**To:** Board of Zoning Appeals  
**From:** Planning and Urban Design Staff  
**Date:** November 14, 2022  
**Re:** **Appeal BOZA2022-052**

**Purpose:**  
Variance 1: This appeal has been filed to grant a variance from the parking minimum requirement. Section 27-467(e) requires paved off-street parking at a ratio of not less than four (4) spaces per 1,000 square feet of floor area in the building in the C-3 District. The total area of the proposed commercial building measures 15,577 square feet, requiring a total of 63 parking spaces. The applicant is requesting 33 parking spaces, a violation of 30 parking spaces.

**Purpose (cont.):** Variance 2: This appeal has been filed to grant a variance from the front yard setback. Section 27-467(d)(2)a states that the front yard setback shall be no less than 25 feet in the C-3 District. The appellant is requesting a front yard setback of one (1) foot and eight (8) inches, a violation of 23 feet and four (4) inches.

**Property Location:** 1201 State Avenue, Kansas City, Kansas 66102

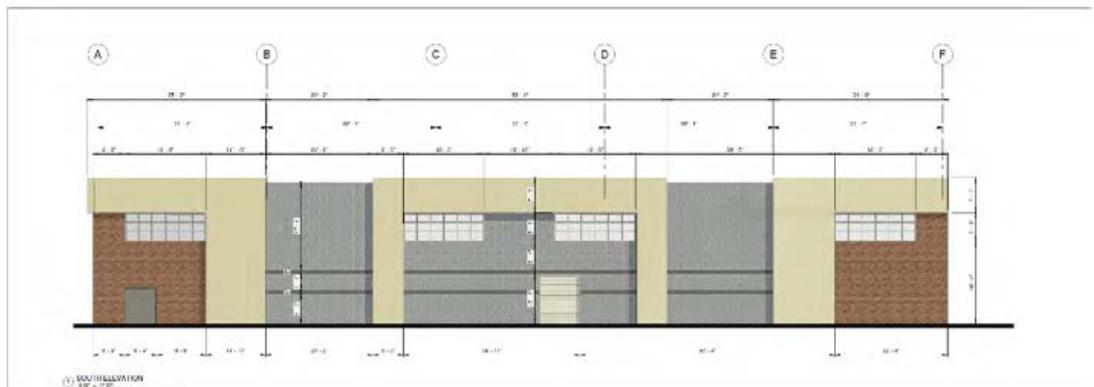
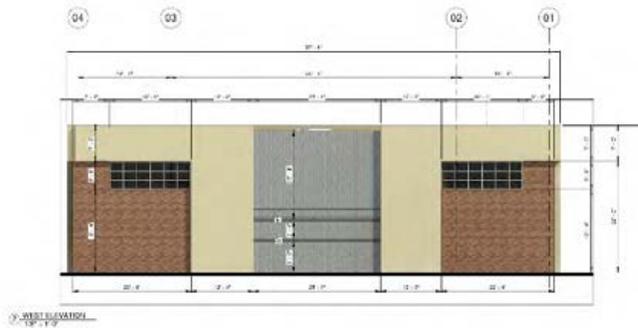
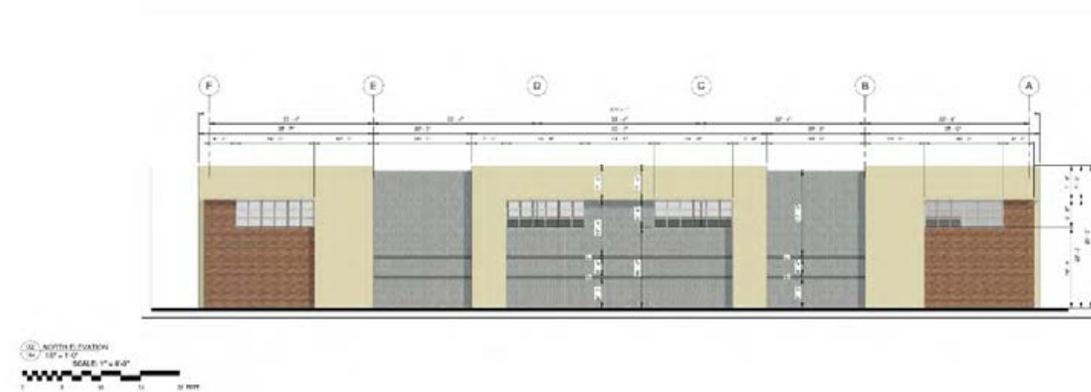
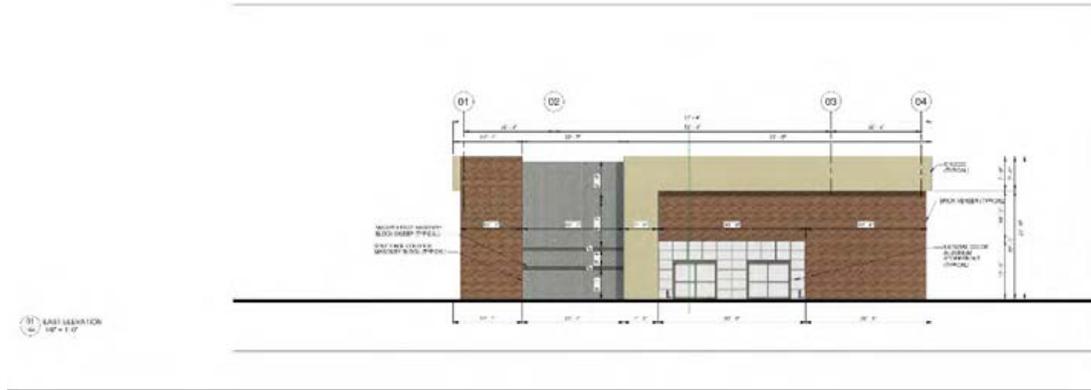
1. The parcel addressed as 1201 State Avenue (Parcel #080853) does not match the dimensions demonstrated in the submitted site plan. The applicant must submit a legal description(s) in compliance with Board of Zoning Appeals application standards for all land involved in the proposed development. This includes submitting the "Affidavit, Property Owner Consent Form" for all parcels that are owned by a party other than the applicant.

2. The location of the proposed building on the site plan (see "Site Plan of 1201 State Avenue Submitted by the Applicant" within the *Attachments* section of this report) does not match the location of the proposed building demonstrated on the site renderings (see "Renderings of the Proposed Building" within the *Attachments* section). Provide a revised site plan and/or rendering in order for them to match with the Development Review Committee (DRC).

3. Has the applicant or property owner issued a traffic study or peer store comparison with the purpose of determining if the proposed commercial use and business model will be able to accommodate a reduction of parking by nearly 50%?

4. Will the applicant maintain the existing retaining wall along State Avenue, or will the retaining wall be repaired if it is damaged in the course of construction?

7. Per Section 27-576(h)(1), for new construction, windows, windows with awnings, and covered pedestrian walkways should total at least 60 percent of the building frontage along public streets or parking lots. The north façade of the proposed building faces State Avenue and has a linear frontage of 169.75 feet. The east façade of the proposed building faces the parking lot and has a linear frontage of 95.25 feet. Therefore, the north and east façades require all windows, windows with awnings, and covered pedestrian walkways must be at least 101 feet and 11 inches, and 57 feet and 3 inches, respectively. The applicant must demonstrate that this requirement has been met.

*Applicant Response: Of the 33 proposed parking spaces, 15 spaces will be used for online order pick-ups and 15 spaces will be used for customers coming in the store. The pick-up parking spaces are expected to turn over every 15 minutes, and the in-store order parking spaces are expected to turn over every 45 minutes.*

Staff Response: This predicted turnover rate will result in an average of two and two-thirds ( $2 \frac{2}{3}$ ) customers served per hour. There are three (3) additional parking spaces that are included in the parking lot count, but which were not taken into account in the turnover rates provided by the applicant.

*Applicant Response: We will replace any portion of the retaining wall and/or sidewalk that is damaged in the construction process with a modified retaining wall and/or sidewalk paving after construction is complete.*
